SIB 61 02 26

SERVICE ACTION: RETROFIT WAKE-UP LINE TO ALEA MODULE

2026-04-23

E-Series	Model Description	Production Date
G73	7 Series Sedan Protection Model (Non-US Specification Vehicles, e.g., used by foreign embassies)	November 2023 – December 2024

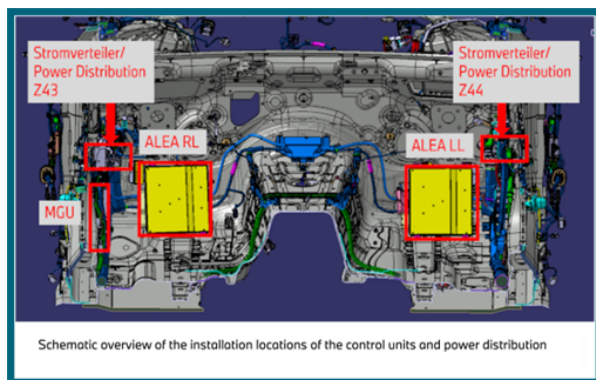
In rare occasions, control of certain vehicle security functions via the Central Information Display (CID) is restricted for a short period of time.

Loss of synchronization between the head unit (HU-H5), the Supplementary (or Add-on) Menu Module (ALEA), and the Central Information Display (CID).

Retrofit a wake-up line between the head unit (HU-H5) and the Supplementary (or Add-on) Menu Module (ALEA).
